## PLAN COMMISSION MEETING AGENDA

# Plan Commission Report

**PROJECT:** Plan Review – Jim Kaiser, PCA Architecture for US Bank

**ADDRESS:** 130 W. Town Square Way

**NORTH ELEVATION**

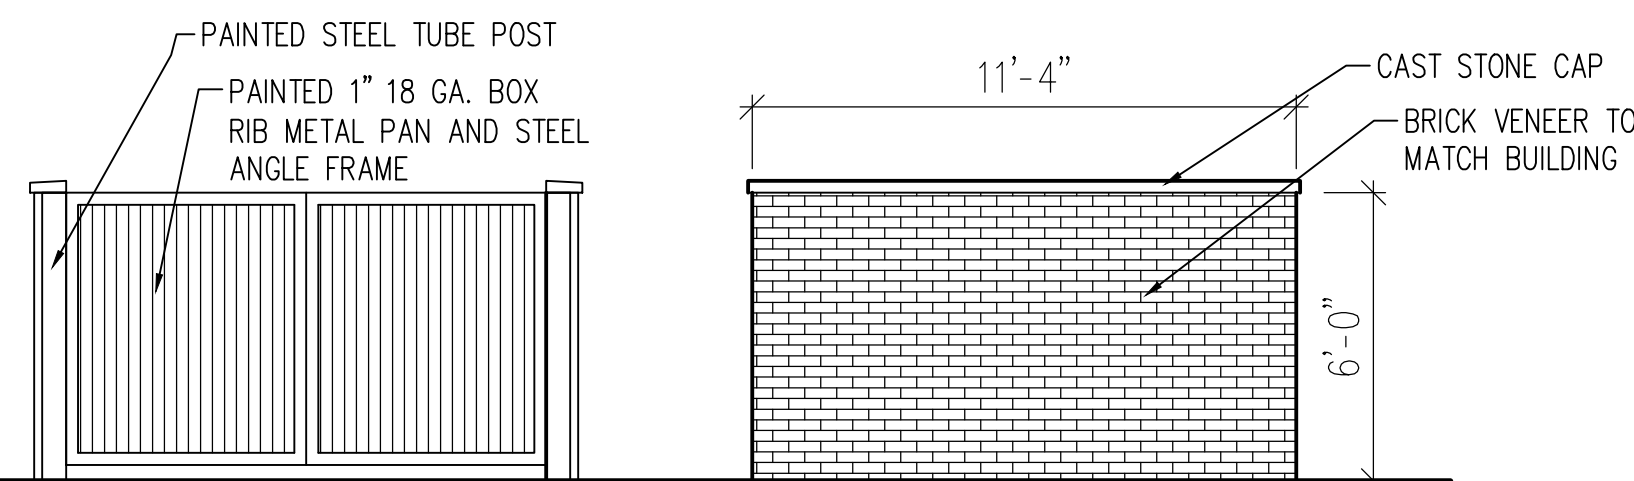
The north elevation contains the highest percentage of brick veneer (66%) as this is the location of the drive-through lanes. Clear glazing (20%) is shown at the drive-up window and within the northwest aluminum storefront. Spandrel (2.5%) is shown along the bottom of the aluminum storefront windows, while frosted glass (2.5%) is shown above the clear glazing as in the west elevation. A minimum of 20% clear glazing is required on this elevation as it is considered a non-entry façade. Up to 50% of the required glazing may be spandrel glazing on this elevation.
